**Subject:** Lugano Subdivision Final Plat

Staff Report

## Final Subdivision Plat Summary and Recommendation

LUGANO SUBDIVISION

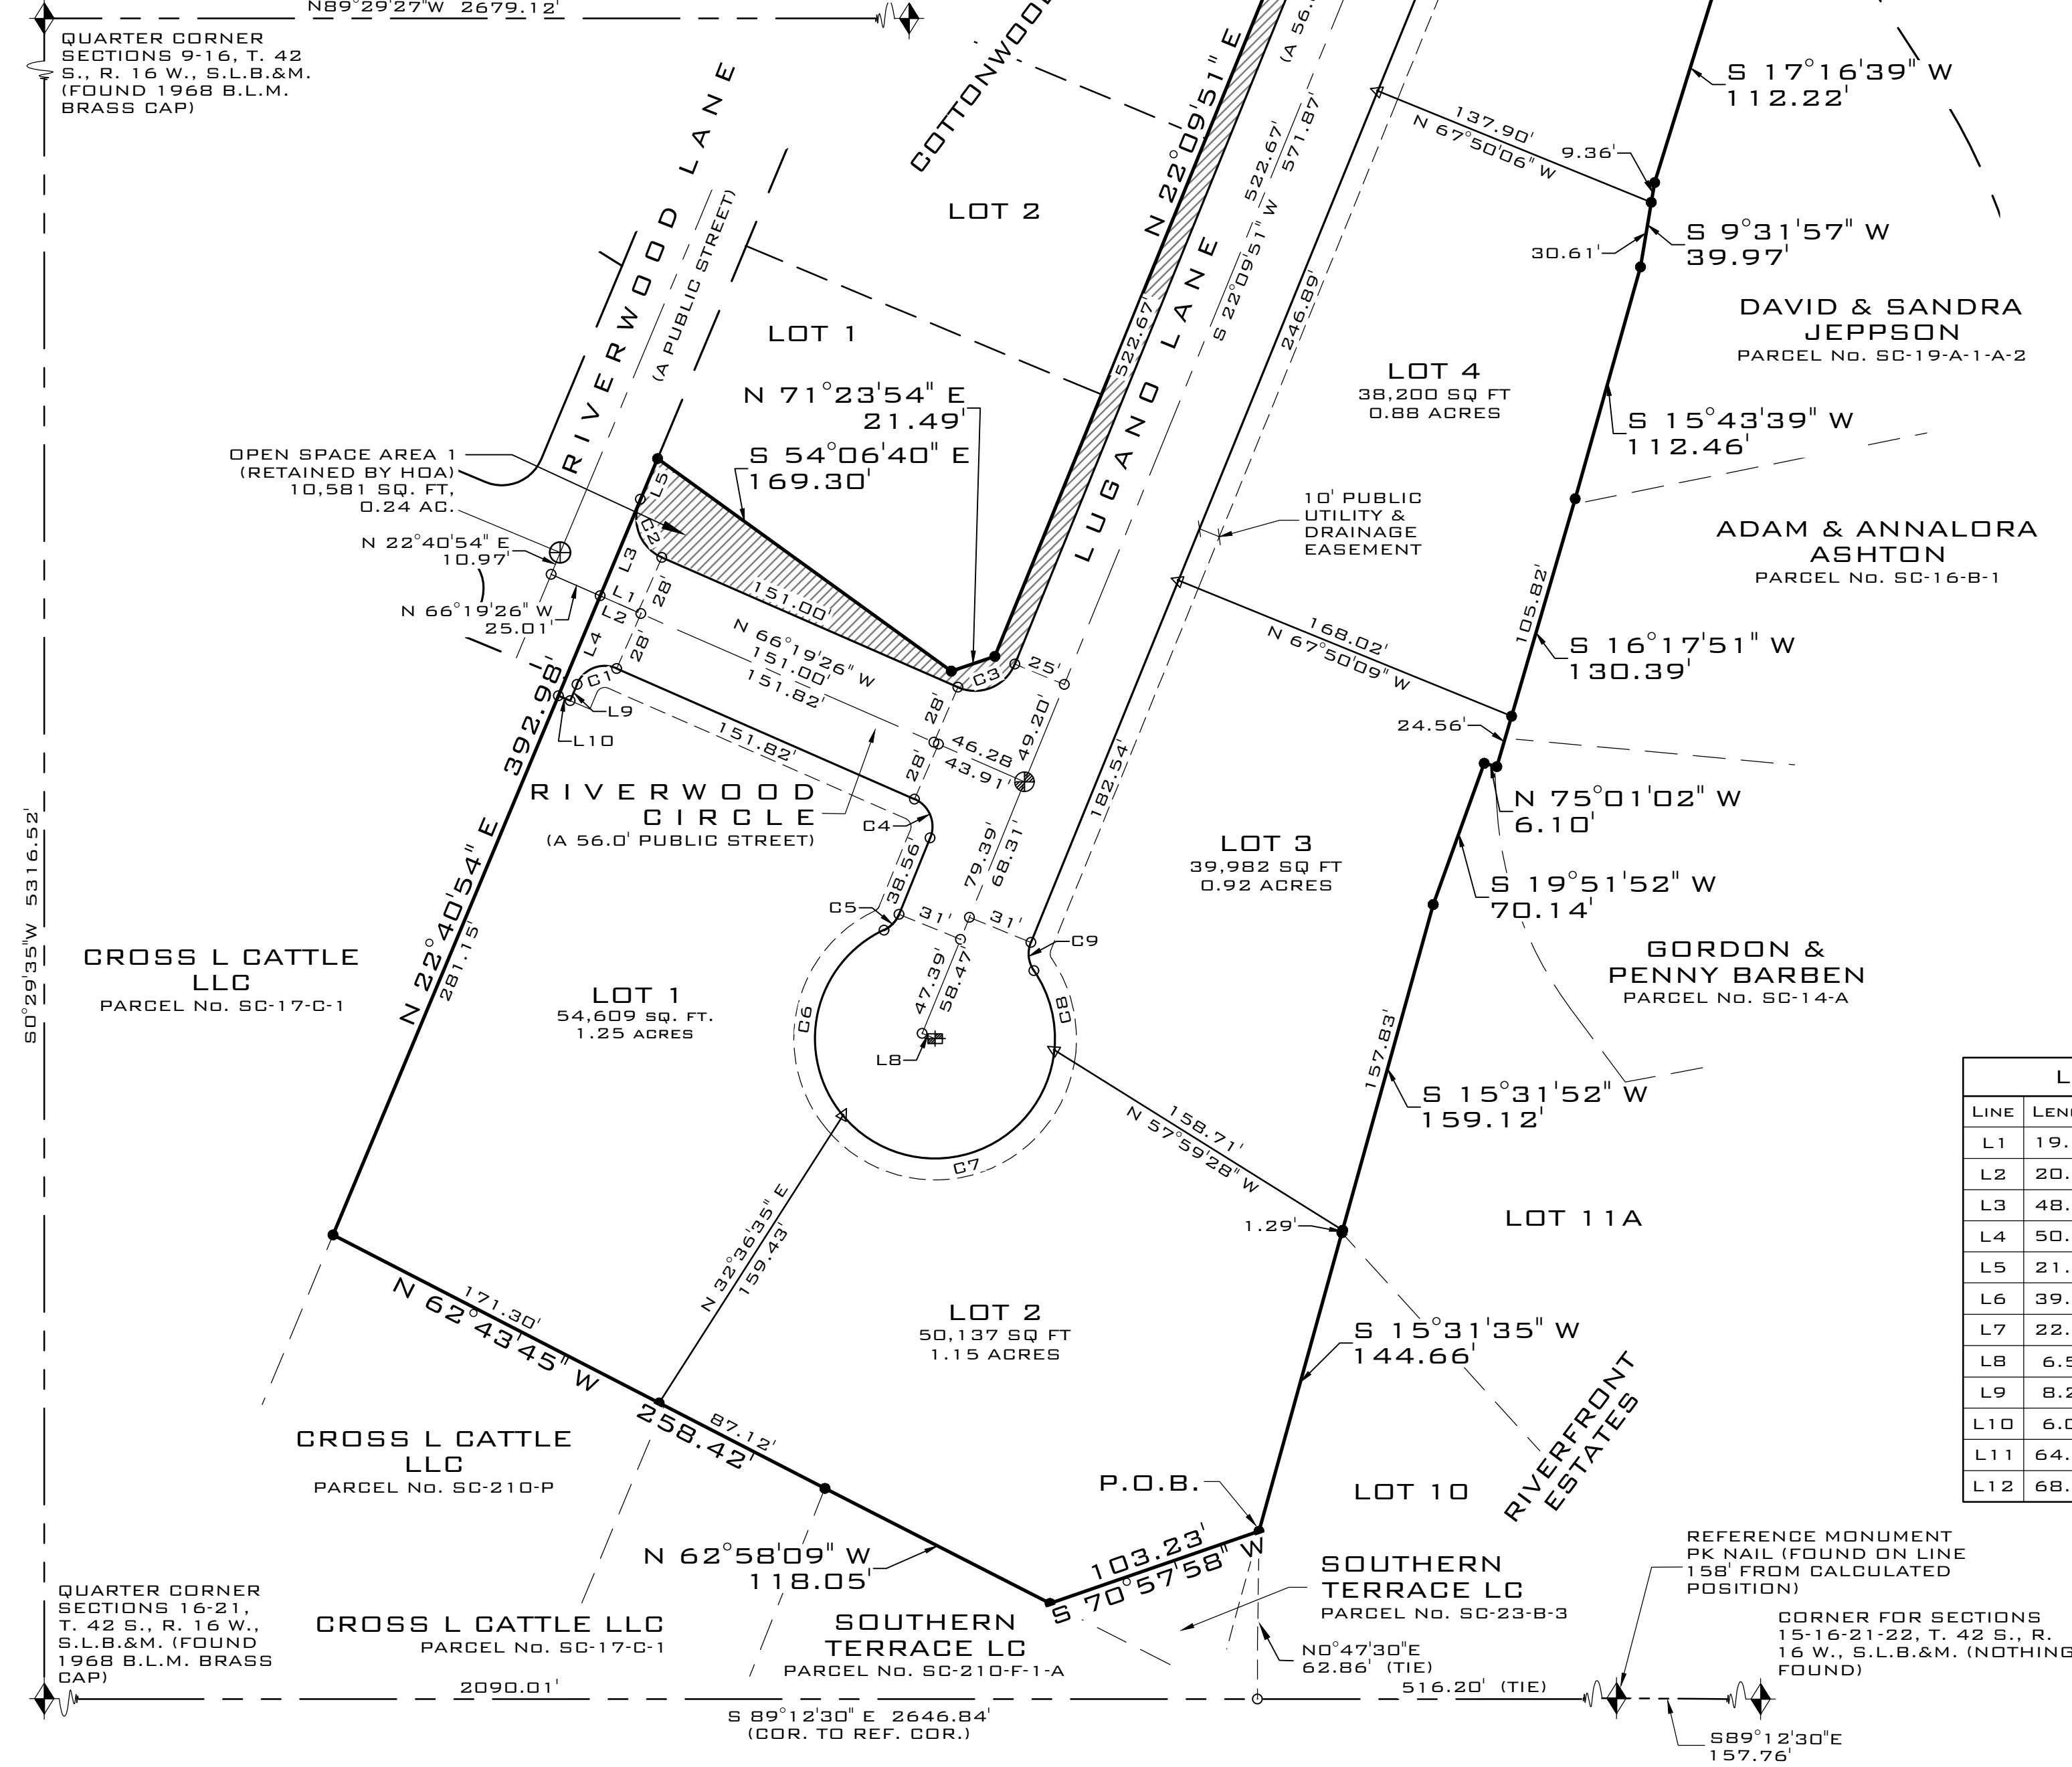
1. **Public Streets & Dedication:** All required public street improvements must meet city standards and be installed or bonded for prior to Subdivision Plat Recordation. The public streets required for this subdivision include a 56-foot cross-section (park strip included) as per the final plat. Additionally, full street improvements are required for the Lot 5 frontage along Vineyard Drive.

4. **Open Space Areas:** The final plat includes two (2) open space areas. One is adjacent to Lot 5, and one is adjacent to existing single-family homes in a different subdivision (Cottonwood Creek #3), as well as on Riverwood Circle providing access to Riverwood Lane. City staff recommends that an HOA be formed to own and maintain Open Space Areas #1 and #2. Notes have been added to the final plat addressing this item.

Recommendations: Public Utility Easements (PUE's) are required.

Recommendations: Public Utility Easements (PUE's) are required to be shown on the final plat. All public streets must be included on the final plat. A mylar with signature blocks is required for the final plat.

1. That the applicant be required to comply with the recommendations from all city reviewing departments.
2. That the applicant be required to install public street improvements (56-foot cross-section with park strip) which meet city standards. That public street improvements be required for the Lot 5 frontage along Vineyard Drive.

5. That the building height for all homes in this subdivision be limited to 35'.
6. That the two (2) open space areas included on the final plat be identified as Open Space Areas #1 and #2. That the applicant be required to form an HOA for maintenance and ownership of the open space areas.
